Access Compliance Report

Public Rights-of-Way

Intersection ID: 45496	Main Street: COTTON_PRESS_RD	Cross Street: COTTON_STAND_RD	Location: SW
ADA ID: F248221A82CD	Ramp Type: PerpDiag	Initial Pass/Fail: Fail	Overall Compliance: No
Severity Score: 12.5			
Codes/Mitigation Info/Possible Solution		Field Measurements/Component Compliance

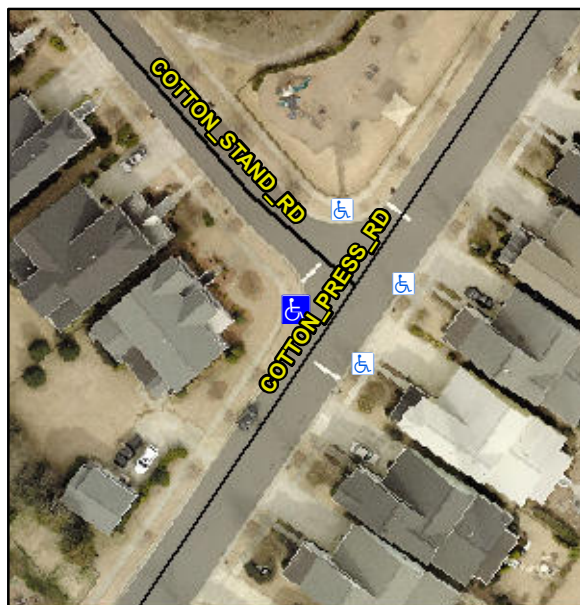
Not Found, R304.2.2

Compliance	Description	Data	Compliance	Description	Data
N/A	Ramp Length (in)	84.0	No	Ramp Slope (%)	9.6
Yes	Ramp Width (in)	48.0	Yes	Ramp XSlope (%)	0.8
N/A	Flare Type LT	N/A	N/A	Flare Type RT	N/A
N/A	Flare Slope LT (%)	N/A	N/A	Flare Slope RT (%)	N/A
N/A	Flare Traversable LT?	N/A	N/A	Flare Traversable RT?	N/A
N/A	Landing Length (in)	N/A	N/A	DWS Provided?	N/A
N/A	Landing Width (in)	N/A	N/A	DWS Contrast?	N/A
N/A	Landing Slope (%)	N/A	N/A	DWS Length (in)	N/A
N/A	Landing X Slope (%)	N/A	N/A	DWS Full Width?	N/A
N/A	Landing Curb? (Y/N)	N/A	N/A	DWS Offset (in)	N/A
N/A	Shared Landing?	N/A			
N/A	Gutter Ponding?	N/A	N/A	Gutter Slope (%)	N/A
N/A	Gutter Lip Ht (in)	N/A	N/A	Gutter X Slope (%)	N/A
N/A	Painted X Walk1?	No	N/A	Painted X Walk2?	No
	X Walk 1 Direction	To SE		X Walk 2 Direction	To NE
N/A	X Walk 1 Width (in)	N/A	N/A	X Walk 2 Width (in)	N/A
	X Walk 1 Slope (%)	3.3		X Walk 2 Slope (%)	0.7
	X Walk 1 X Slope (%)	0.7		X Walk 2 X Slope (%)	0.4

Remove & Replace Curb Ramp With Two New Directional Ramps or Equivalent.
